Access Compliance Report Public Rights-of-Way (Pedestrian Signals)

Main Street: CROWN_VALLEY_PKWY Cross Street: O_NEILL_DR Location: SE

ADA ID: SGRK211025135807 Signal Type: One Push Button-Non APS Overall Compliance: No Severity Scores: BTN 1: 25 BTN 2: N/A No BTN: N/A

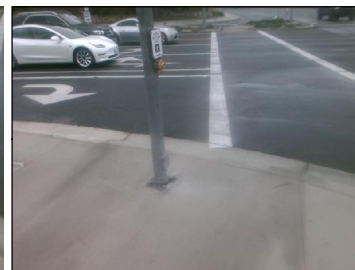
OC Std/PROW: R404.2

Possible Solutions: Remove and Replace Clear Space.

Total Cost: \$ 378
